Minor Interior Renovations at
CASCO BAY HIGH SCHOOL Phase I Part B
196 Allen Avenue, Portland, Maine

TITLE
PHASE 1 PART B
MECHANICAL
DEMOLITION PLAN
MECHANICAL PLAN

SHEET
MH-101

PROPOSAL REQUEST #2 ~ 27 OCTOBER 2014 ~ NOT FOR CONSTRUCTION

A1	MECHANICAL DEMOLITION THIRD FLOOR PLAN
1/8" = 1'-0"

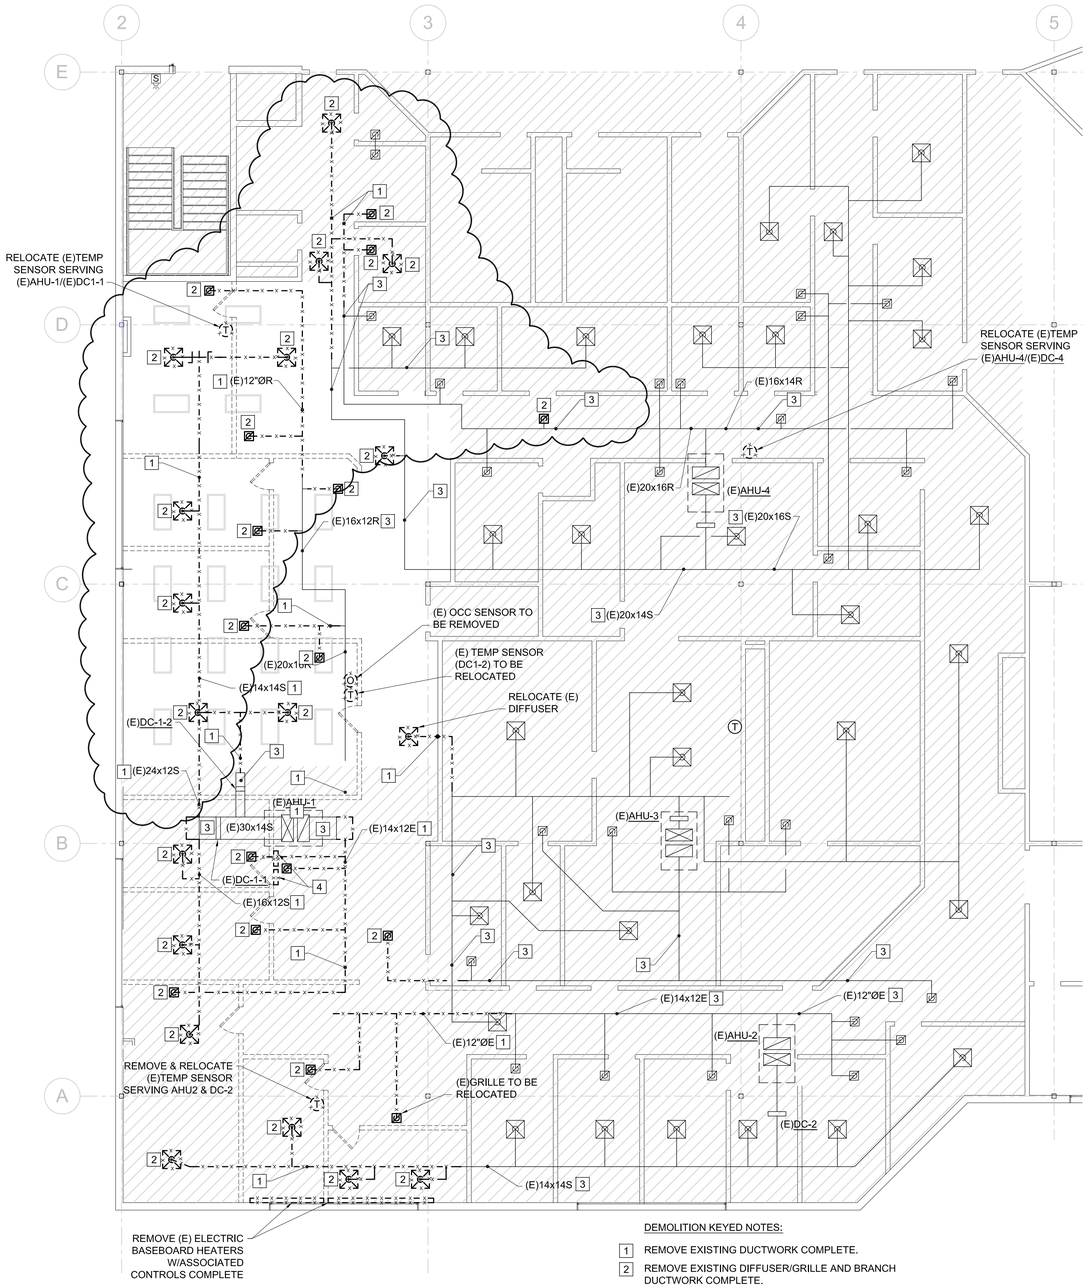
1. REMOVE EXISTING DUCTWORK COMPLETE.
2. REMOVE EXISTING DIFFUSER/GRILLE AND BRANCH DUCTWORK COMPLETE.
3. EXISTING DUCTWORK TO REMAIN.
4. (E)CONTROLLERS SERVING (E)AHU-1/(E)DC 1-2 (ABOVE CEILING) TO BE RELOCATED AS REQUIRED TO FACILITATE THE RENOVATIONS

A6	MECHANICAL THIRD FLOOR PLAN
1/8" = 1'-0"

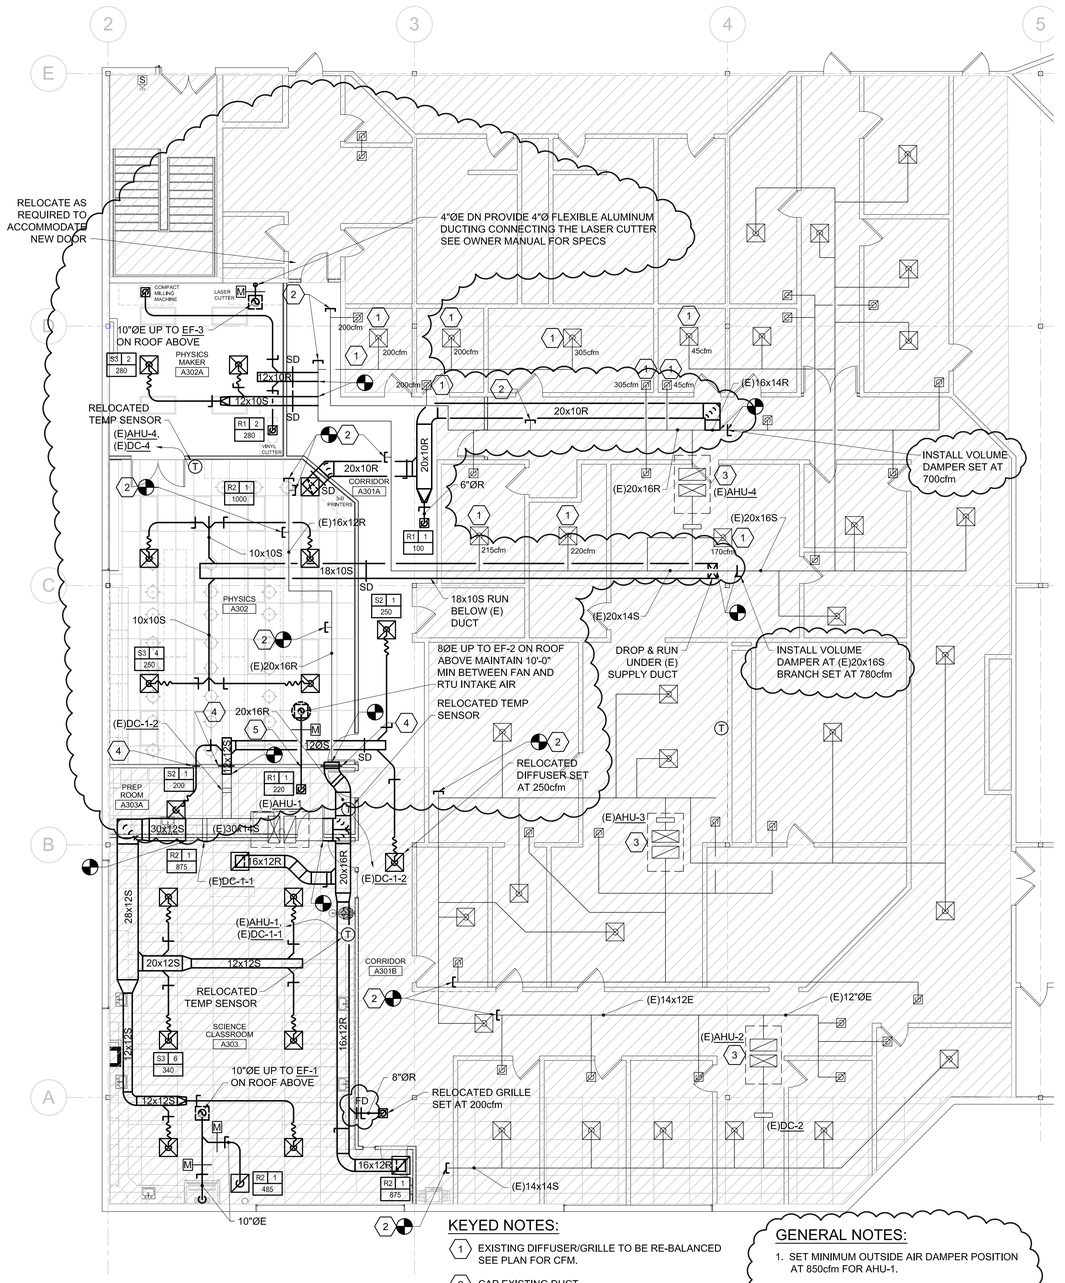
1. EXISTING DIFFUSER/GRILLE TO BE RE-BALANCED SEE PLAN FOR CFM.
2. CAP EXISTING DUCT.
3. RE-BALANCE (E)AHU SYSTEM TO ACCOMMODATE REMOVAL OF SUPPLY AND RETURN TERMINALS AS OUTLINED ON THE DEMOLITION PLAN.
4. FIRE DAMPERS UNDER CHANGE ORDER REQUEST CP006.
5. FIRE DAMPER NOT REQUIRED IF THERE IS NO FLEX DUCT USED.
